Access Compliance Report Public Rights-of-Way (Curb Ramps)

Main Street: E_CENTER_ST Cross Street: HEWES_ST Location: SW

ADA ID: RPRK211223131327 Ramp Type: Type 1 - Perpendicular Initial Pass/Fail: Fail Overall Compliance: No Severity Score: 15

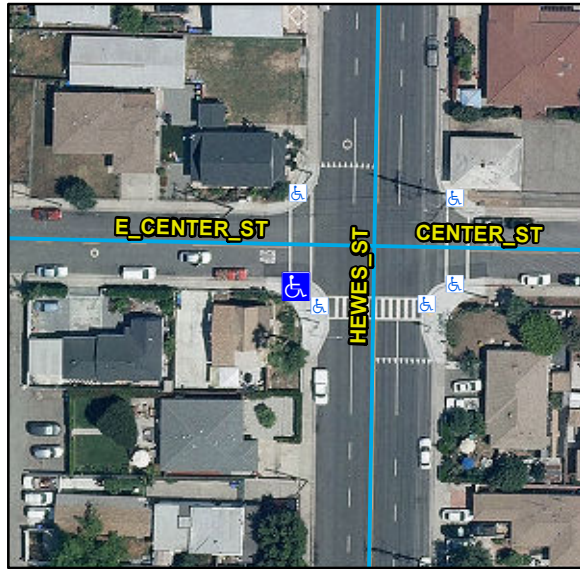
Compliance	Description	Data	Compliance	Description	Data
N/A	Ramp Length (in)	60	N/A	Flare Type LT	
Yes	Ramp Width (in)	48			N/A
No	Ramp Run Slope (%)	8.8	N/A	Flare Slope LT (%)	N/A
Yes	Ramp Cross Slope (%)	1.7	N/A	Flare Traversable LT	N/A
N/A	Landing Present	N/A	N/A	Flare Type RT	
N/A	Landing Length (in)	N/A			N/A
N/A	Landing Width (in)	N/A	N/A	Flare Slope RT (%)	N/A
N/A	Landing Run Slope (%)	N/A	N/A	Flare Traversable RT	N/A
N/A	Landing Cross Slope (%)	N/A	N/A	DWS Provided	N/A
N/A	Landing Movement Obstructed?	N/A	N/A	DWS Contrast	N/A
	Landing Movement Type	N/A	N/A	DWS Length (in)	N/A
N/A	Landing Shared	N/A	N/A	DWS Full Width	N/A
N/A	Clear Space	N/A	N/A	DWS Offset Left (in)	N/A
N/A	Clear Space To Crosswalk (in)	N/A	N/A	DWS Offset Right (in)	N/A
N/A	Marked Crosswalk 1	Yes	N/A	Marked Crosswalk 2	N/A
	Crossing 1 Direction	N		Crossing 2 Direction	N/A
	Marked Crosswalk 1 Width (in)	144		Marked Crosswalk 2 Width (in)	N/A

Remove & Replace Entire Ramp.

R304.2.2, STD 1115
